SANITARY SEWERS		
- VETERANS ADMINISTRATION FACILITY -		
CANANDAIGUA, NEW YORK		
DATE: 10/24/42		DWG. NO. 29

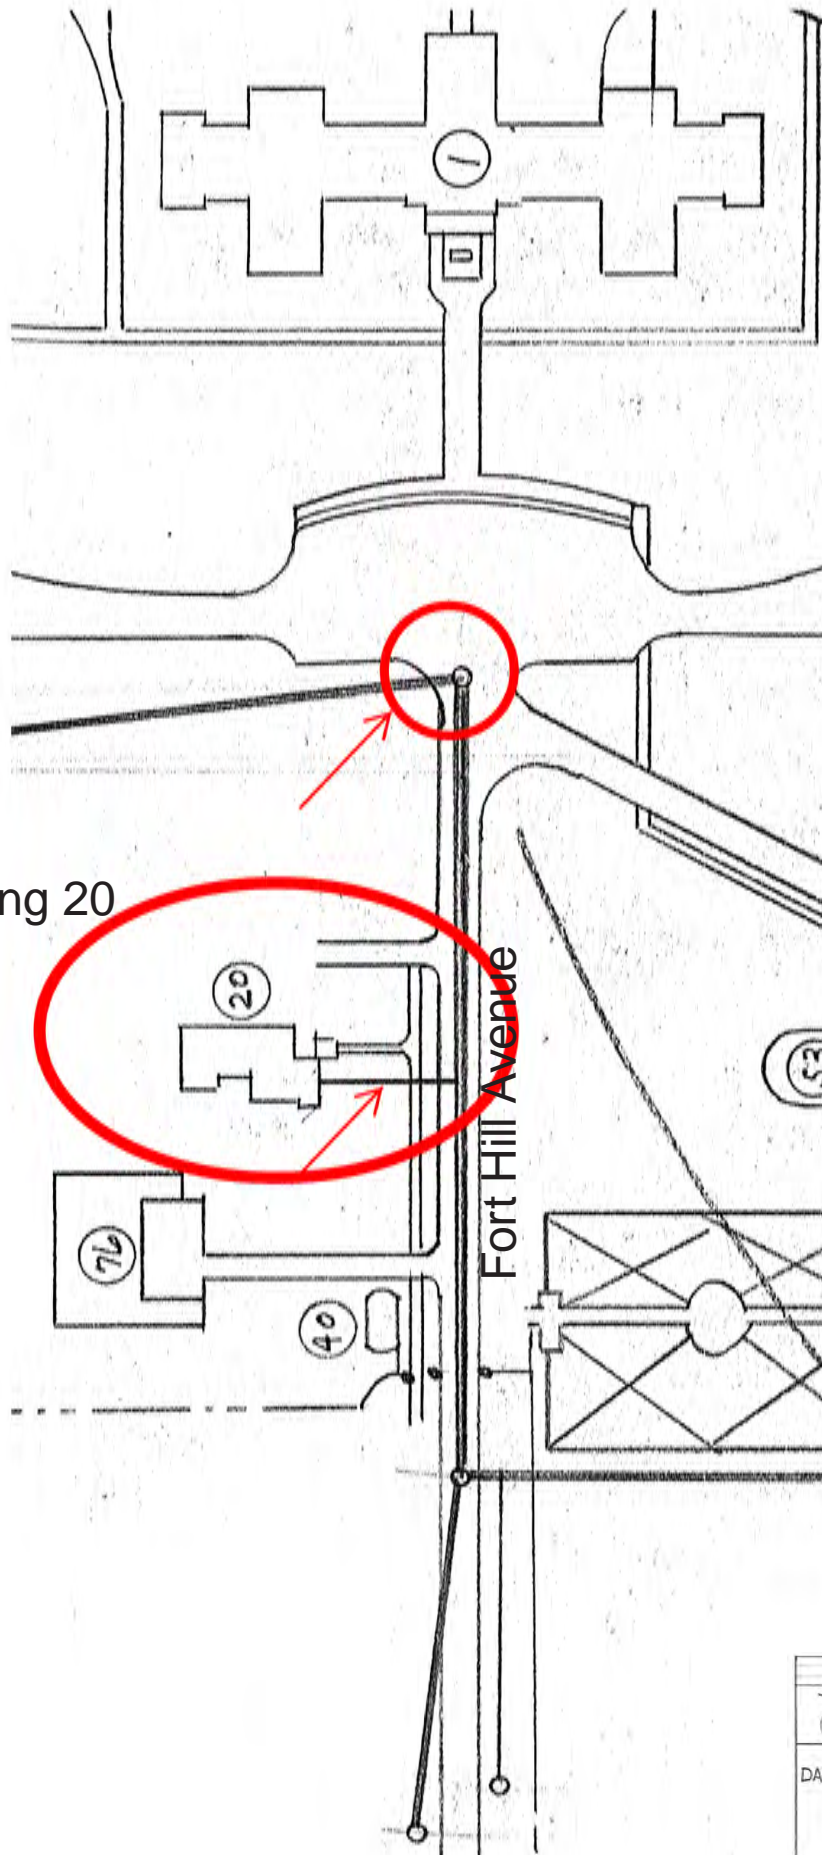
**Q4.)** *Will excavation outside of the shaded area on drawing for sanitary removal be considered additional work?*

**Q5.)** *Are we to bid the removal of the abandoned manhole on East Street and Fort Hill?*

**A4.)** Excavation outside the shaded area is not included in the contract. Any work deemed necessary by the Contracting Officer outside the shaded will be additional work.

**A5.)** No, the man hole shall be abandoned in place, however the connection of the abandoned line at building 20 shall be disconnected, cut at sub-grade and capped.
